SUBJECT: ZON-25-0011 (ARC-25-0011) 261 MIRAFLORES DR

MEETING: APRIL 23, 2025 ARCOM
MAY 14, 2025 TC

ARC-25-0011 (ZON-25-0011) 261 MIRAFLORES DR (COMBO). The applicant, Fernanda Niven (Maura Ziska, Representative), has filed an application requesting Architectural Commission review and approval for a one-story garage addition to an existing single-story residence, with related setback and angle of vision variances. Town Council shall review the application as it pertains to zoning relief/approval.

MIRAFLORES DRIVE
Existing Site Plan

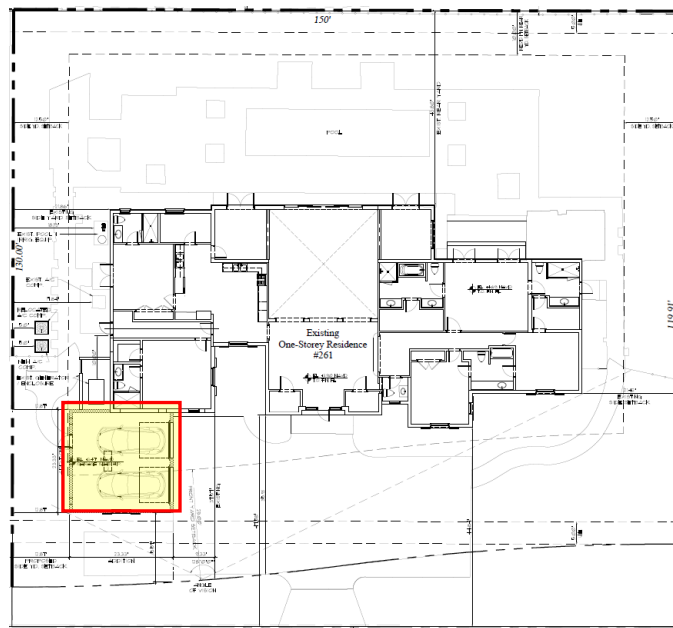
The subject property is located on the north side of Miraflores Drive, the second parcel east of North Lake Way. The existing residence is a single-story ranch style home constructed in 1951. The scope of work includes the addition of a two-car garage and renovation of the existing garage with minor exterior fenestration adjustments to accommodate the remodel including a new circular window at the front façade and relocation of an existing exterior door at the west side of the structure. The addition will match existing architectural details and finishes and will add approximately 535 SF of lot coverage, which translates to an increase of 3%. The only landscape adjustments proposed are related to the new addition. No other modifications are being proposed to the structure or site as part of this application.

Plan of the portion of the existing structure and proposed addition extending beyond the permitted angle of vision.

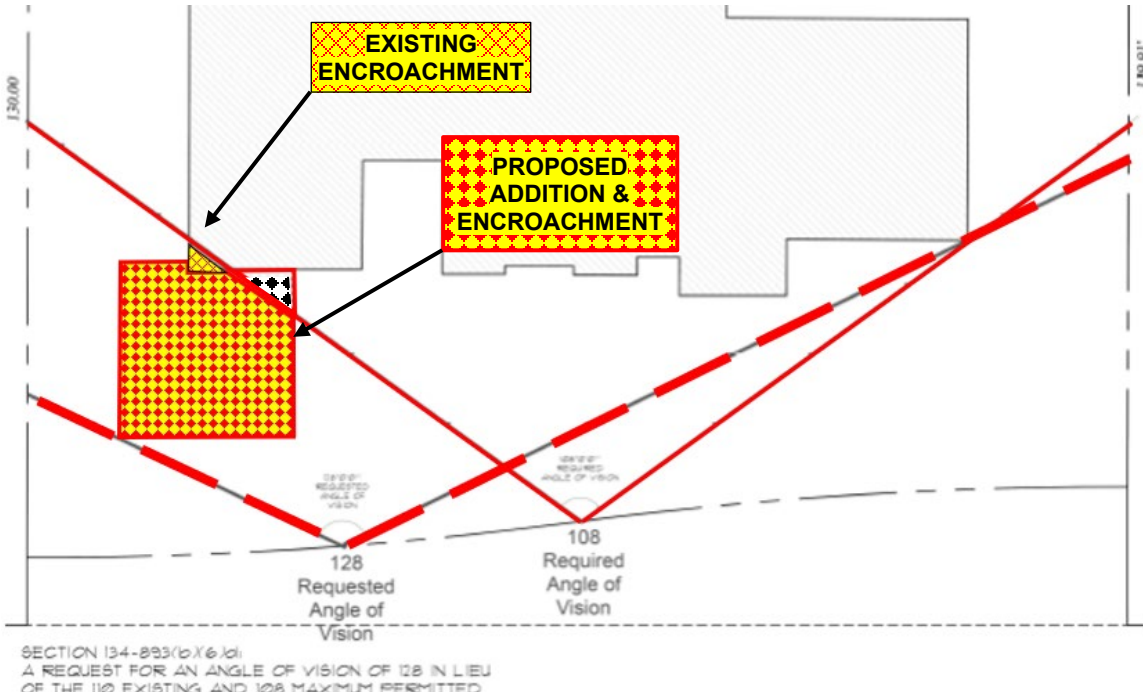
Variance 1 pertains to the angle of vision requirement. No portion of any individual building is permitted to extend beyond a line drawn from the front property line 50 degrees either side of a line drawn perpendicular or radial to the front yard property line. For lots that exceed the minimum required lot width, the base angle of vision (50 degrees on either side of the line) is increased by two degrees for each ten feet of increased lot width over the minimum up to a maximum additional width of 40 feet in the R-B district. All structures must be sited within the angle of vision. In this application, the existing angle of vision is already nonconforming at 110° with a maximum angle of vision of 108° permitted and a variance required for the 128° angle of vision proposed.

Code Section	Permitted	Proposed	Variance
VARIANCE 1: Sec. 134-893(b)(6)d	Maximum Angle of Vision 108° (110° existing)	Angle of Vision 128°	+20°

Staff has mentioned in the past that the angle of vision regulation, designed to control mass as viewed from the street, should not apply to one-story structures and as the Town moves towards Code Reform this is one of the specific regulations that shall be critically examined.

SECTION 134-893(b)(5)a
 A REQUEST FOR A FRONT YARD SETBACK OF 15.57' IN LIEU OF THE 25.83' EXISTING
 AND 25' REQUIRED FRONT SETBACK

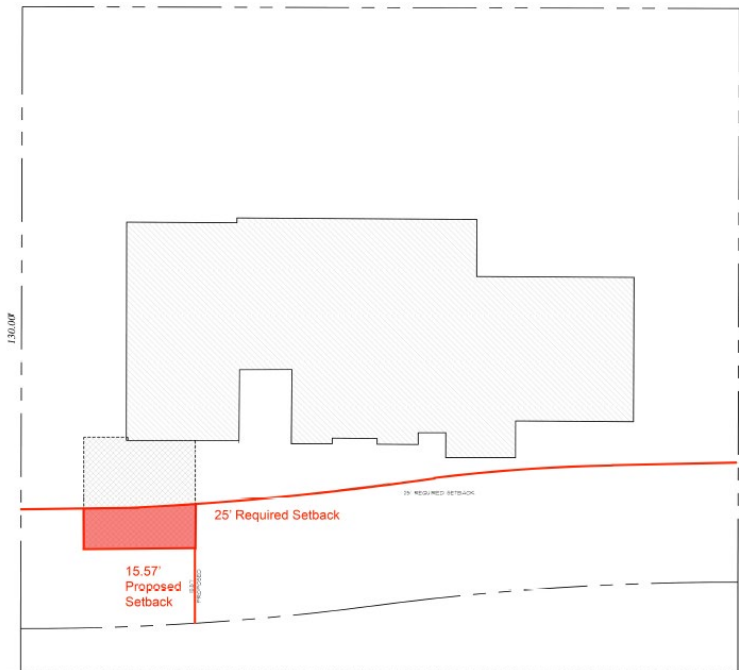
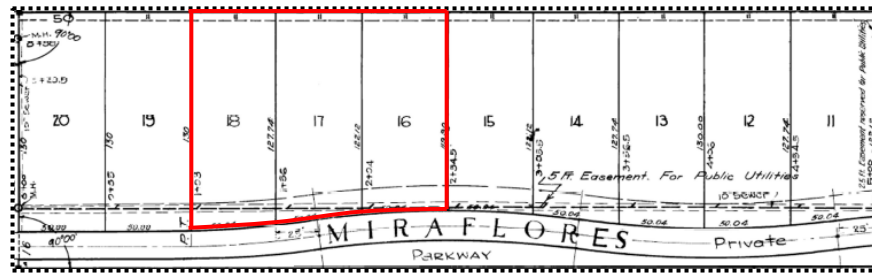
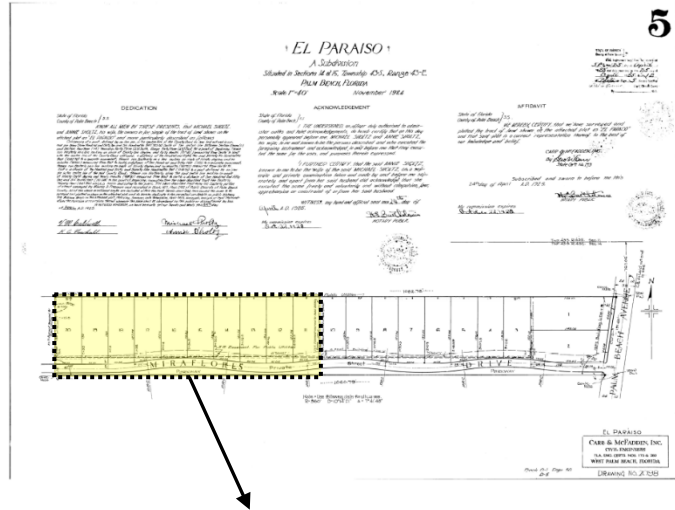
Variance 2 pertains to the front yard setback encroachment. The proposed addition will encroach within the front yard setback by just under 10 feet. The existing front setback at the west side of the structure is 37.57' with 15.57' proposed, in lieu of the 25' minimum required. Staff will note that the lot configuration is atypical with a meandering front property line that is set back several feet away from the finished edge of pavement. The lot configuration is a condition of the original plat for Miraflores Drive, which reserved area for a meandering "parkway" and private street between street and front property line. The subject property is inclusive of lots 16 through 18 of the El Paraiso subdivision, recorded in 1925. The actual development of the right of way is a relatively straight line with landscape open space between the property line and edge of pavement. Measured from the edge of pavement, the distance from the edge of pavement to the new addition is just over 25', which would be zoning compliant if the property configuration was in keeping with typical conditions for the North End with property lines abutting the paved right of way.

Code Section	Required Front Setback	Proposed	Variance
Sec. 134-893(b)(5)a	25' (37.57' Existing)	15.57'	-9.43'
